128LD

Parts List No. 545192138		Husqvarna ® PARTS LIST	MODEL 128LD (Lowes)
Date 5/28/09	Replaces 545192138 - 4/22/09		NOTE : Illustration may differ from actual model due to design changes.

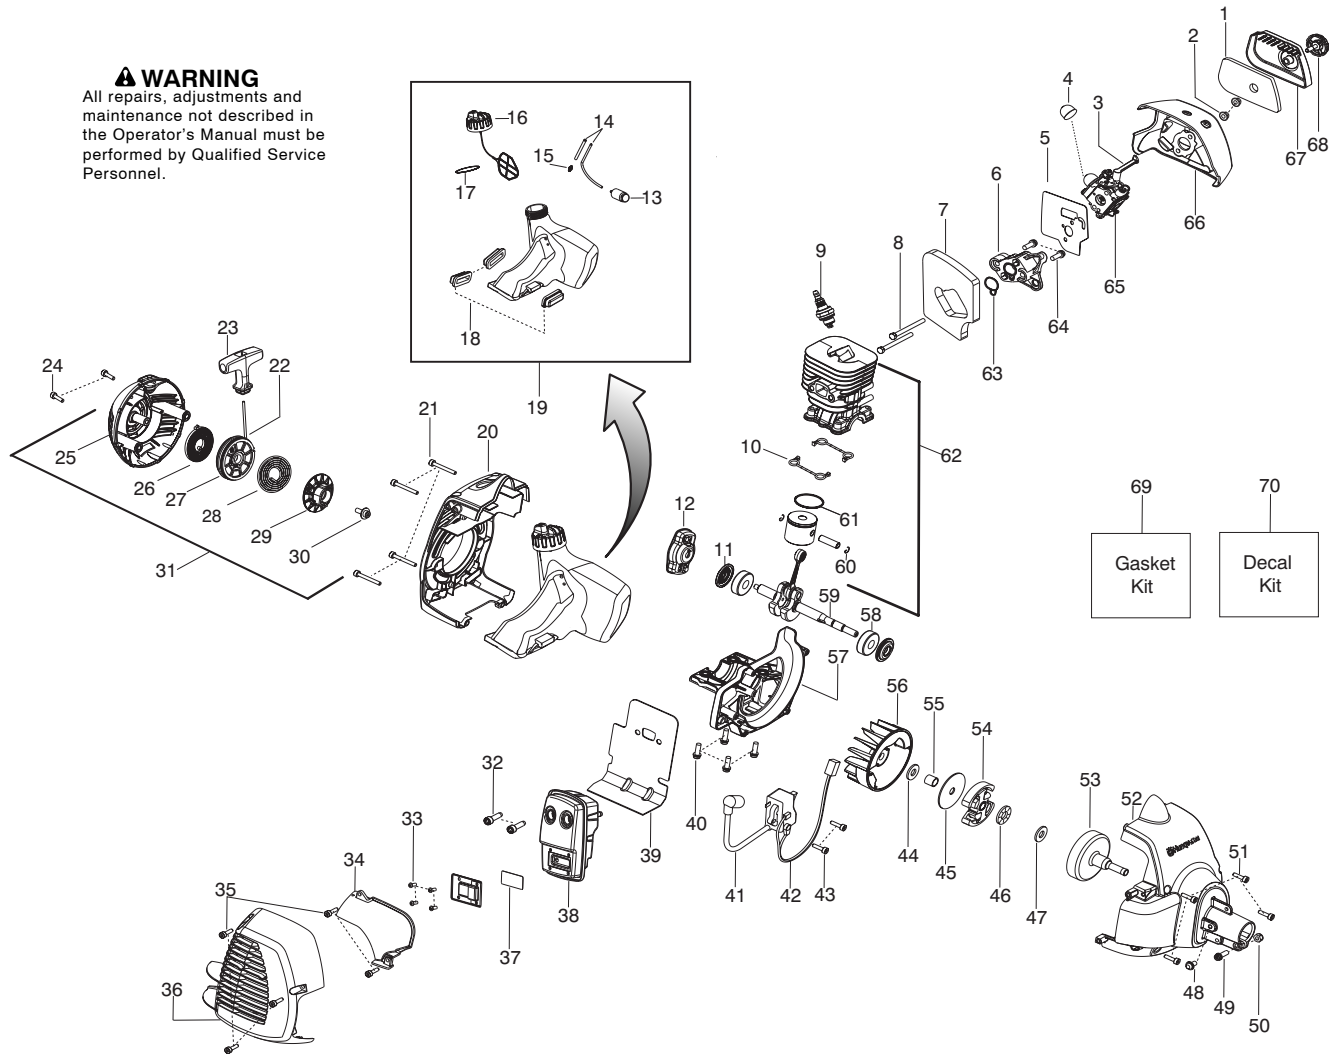
Note : Due to product improvements, your unit may have a different starter system.
Please refer to the serial number on your unit and order the parts below.

Note : Due to product improvements, your unit may have a different fuel tank assembly.
Please refer to the serial number on your unit and order the parts below.

Note : Due to product improvements, your unit may have a different starter housing assembly. Please refer to the serial number on your unit and order the parts below.

Note : Due to product improvements, your unit may have a different piston, cylinder & crankcase. Please refer to the serial number on your unit and order the parts below.

Serial Number - 2008-365N and lower, please use the following parts:

- Ref.# 12 - 530016475 Washer - Starter
- Ref.# 13 - 545160301 Spring - Starter Cup
- Ref.# 14 - 545102303 Assy - Starter Cup
- Ref.# 15 - 530059800 Coupling - Starter

Serial Number - 2009-001N and higher, please use the following parts:

- Page 2, Ref.# 12 - 503873305 Assy - Starter Pawl

Serial Number - 2008-365N and lower, please use the following parts:

- Ref.# 17 - 545081897 - Kit - Fuel Line
- Ref.# 20 - 545105105 - Assy - Fuel Tank (Incl. filter, lines, cap)

Serial Number - 2009-001N and higher, please use the following parts:

- Page 2, Ref.# 14 - 530069599 - Kit - Fuel Line (incl. 15)
- Page 2, Ref.# 15 - 530023877 - Fitting - Fuel Line
- Page 2, Ref.# 19 - 545180870 - Kit - Fuel Tank Assy

Serial Number - 2008-365N and lower, please use the following parts:

- Ref.# 23 - 545029901 - Kit - Rope
- Ref.# 24 - 530150318 - Handle - Starter
- Ref.# 26 - 545029603 - Starter Hsg w/eyelet
- Ref.# 27 - 545029801 - Kit - Starter Spring
- Ref.# 28 - 545029701 - Kit - Starter Pulley
- Ref.# 30 - 545106301 - Assy - Starter Housing

Serial Number - 2009-001N and higher, please use the following parts:

- Page 2, Ref.# 22 - 545008079 - Kit - Rope
- Page 2, Ref.# 23 - 545043204 - Handle - Starter
- Page 2, Ref.# 25 - 545186502 - Starter Hsg w/eyelet
- Page 2, Ref.# 26 - 545008087 - Kit - Spring
- Page 2, Ref.# 27 - 545008078 - Kit - Starter Pulley
- Page 2, Ref.# 28 - 544038802 - Spring - Driver
- Page 2, Ref.# 29 - 544038702 - Pulley - Driver
- Page 2, Ref.# 31 - 545186501 - Assy - Starter Housing

Serial Number - 2008-365N and lower, please use the following parts:

- Ref.# 9,55,60 - 545003378 Kit - Cyl., Piston, Crankcase
- Ref.# 57 - 545030001 Kit - Crankshaft

Serial Number - 2009-001N and higher, please use the following parts:

- Page 2, Ref.# 10 - 545008084 Seal - Cylinder (kit)
- Page 2, Ref.# 57 - 545195601 Crankcase
- Page 2, Ref.# 59 - 545195202 Assy-Crankshaft
- Page 2, Ref.# 62 - 545008082 Kit - Cylinder / Piston
